RE: Hillside Commercial Park

HILLSIDE COMMERCIAL PARK
Water Quality Issues and Concerns
March 2009

**re: Hillside Commercial Park
Drainage Review
Prepreliminary/Preliminary/Final
Subdivision and Site Plan
Lots 68.11-1-39 and 40 and 68.16-1-1
Hillside Avenue, Pearl River, NY**

SOIL EROSION & SEDIMENT CONTROL

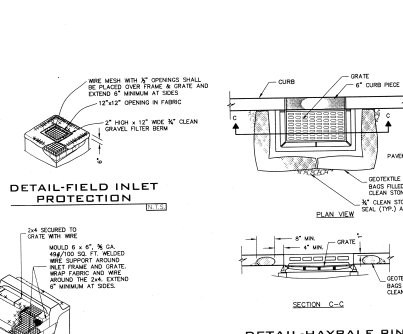
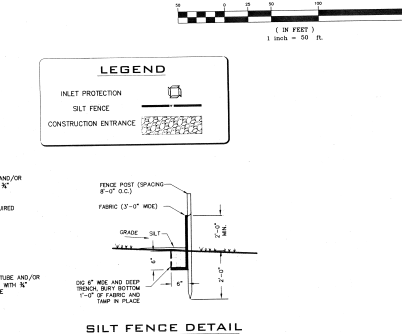
While, according to the report, “the basin has been sized to provide zero net increase in runoff leaving the site in the southerly direction”, runoff originating at any point to the south of the drainage basin will flow to the southwest, and directly into the larger wetland. Because the basin has been designed on the north side of the project site (at a higher elevation), it would be impossible for the natural flow of stormwater to be directed to the basin from the southern portion of the site. The proposed facility design including wetland boundaries is enclosed as **Exhibit 3**.

Stormwater runoff from the designed warehouse and parking facility would contain numerous pollutants. In addition, the volume and velocity of the flow would be increased due to the increase of impervious surfaces. The untreated runoff would enter the wetland without a buffer zone and would cause degradation to the quality of the wetland.

In order for the wetland to continue to provide the critical function of flood protection, maintaining the health of the system is important. The implementation of a buffer zone would allow the wetland to maintain its function, but the proposed design does not account for this transitional area.

Water leaving the drainage basin would be treated with filters, but in order for the runoff to be conveyed through this system before reaching the wetland, the flow would need to be redirected to the north.
